**CONTINUING ELIGIBILITY INSPECTION (CEI) REPORT
FOR HURRICANE & SHORE PROTECTION PROJECTS**

1. Project Name: Pago - Nuuuli Shore Protection Project
2. Date of Inspection: April 10, 2002
3. Inspection Personnel:

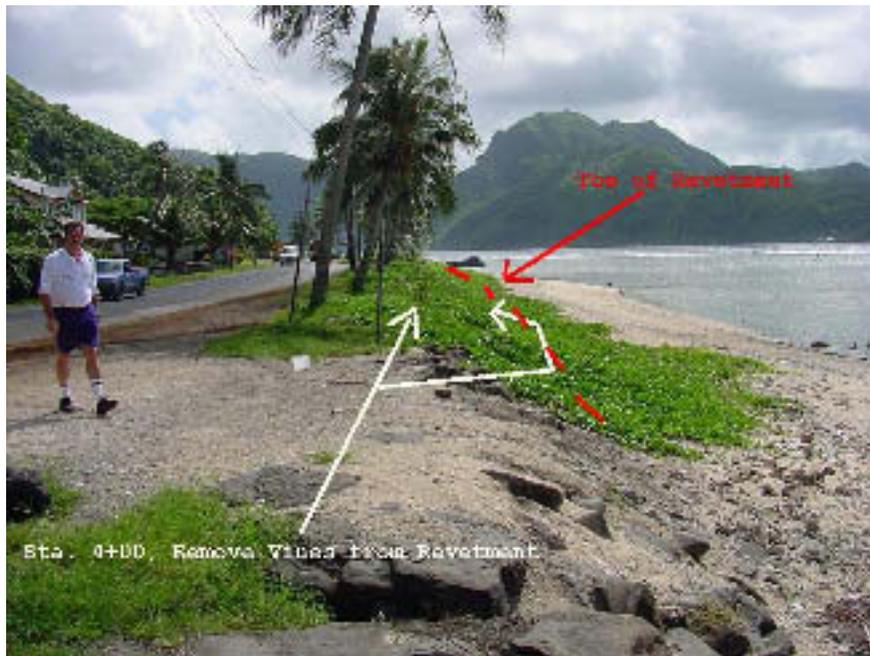
- a. Sta. 0+50, Monitor approximately 20LF of crest settling (adjacent the bus stop).

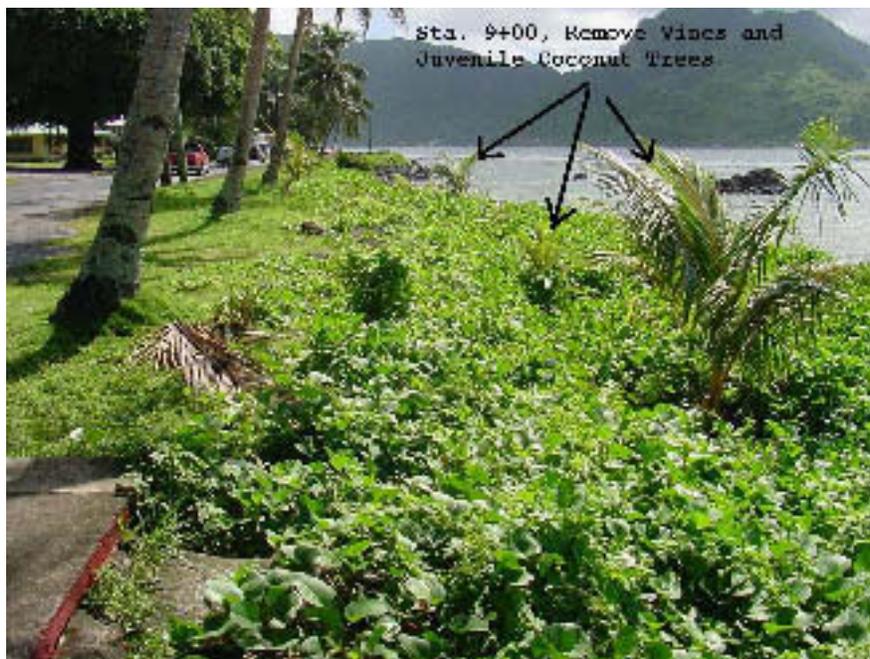
b. Sta. 4+00, Remove vines from revetment.
